- A. Title: Public Hearing for 11th Avenue Duplex (File Nos. CUP18-01 and DR18-09)
Presenter: Sarah Fox, Senior Planner

STAFF REPORT

11TH AVENUE DUPLEX

FILES: CUP18-01 AND DR18-09

C3

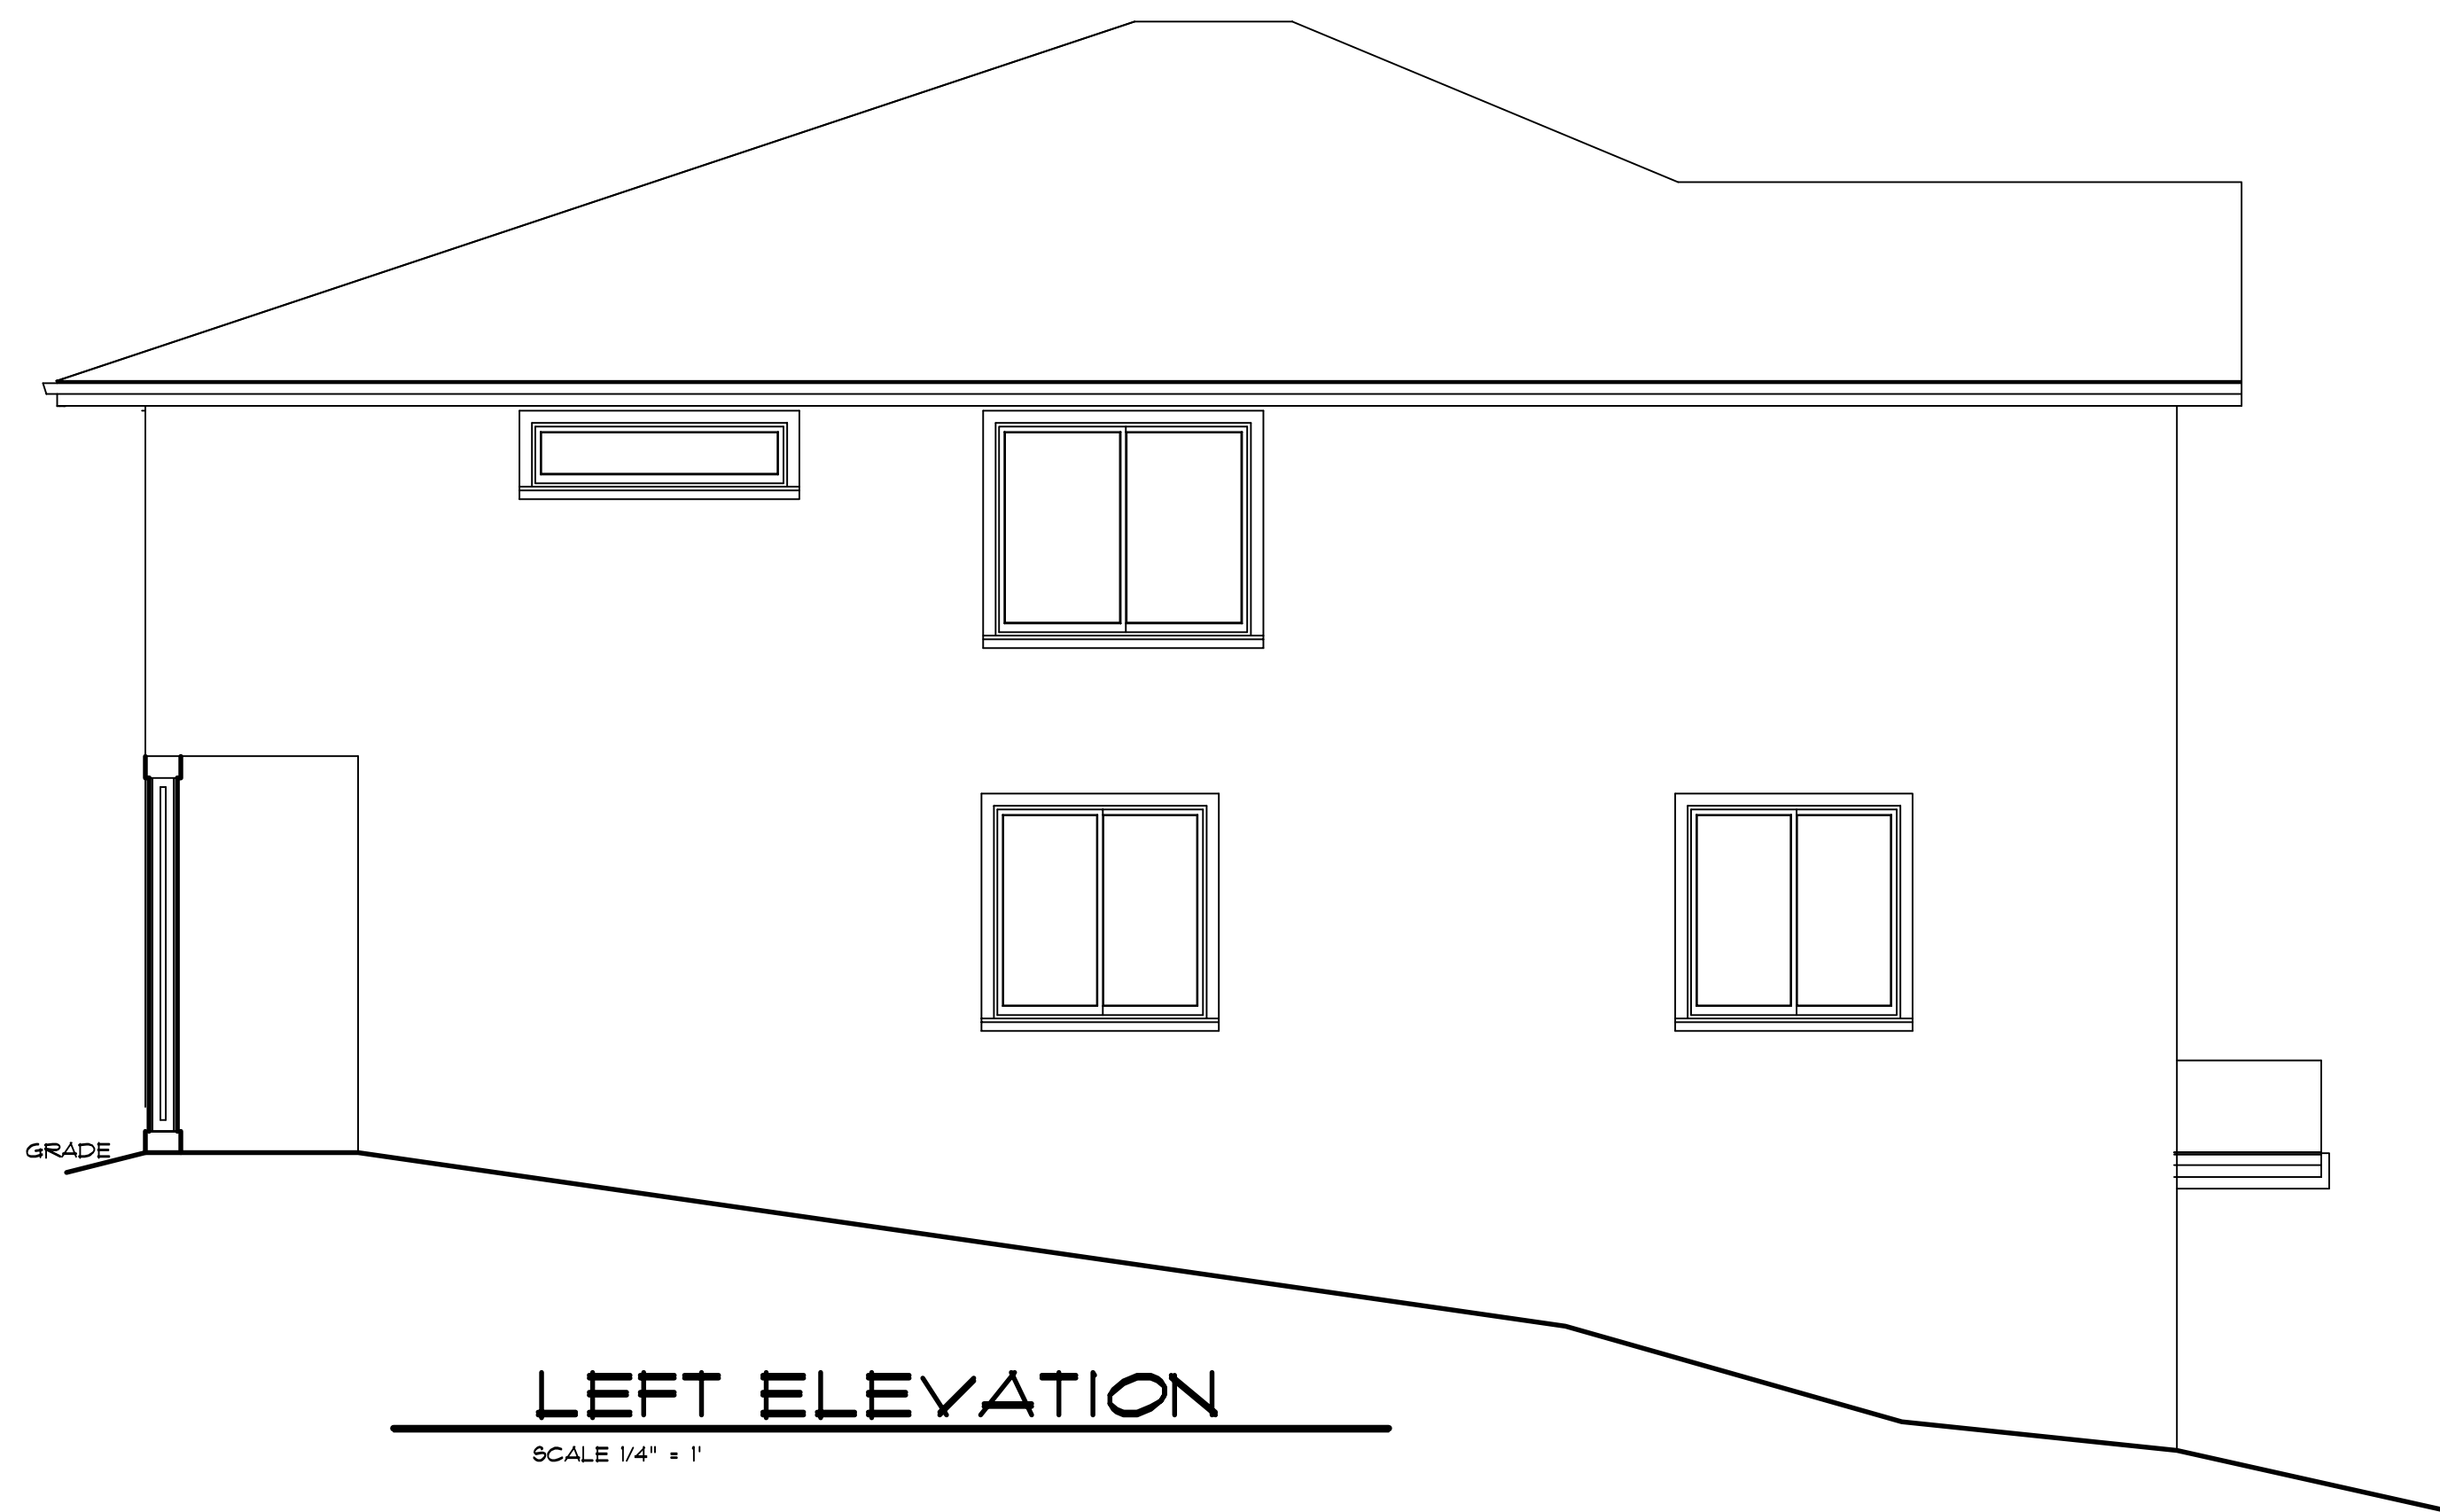
The applicant has proposed a design for the duplex that staggers the units rather than being flush with one another and the front doors are visible from the street. The front doors are set forward of the garage doors for both units as demonstrated on Sheet A2.00. Design Review criteria is discussed in the following section.

Findings: The garages will have a glass panel and are less than 50% of the front façade.
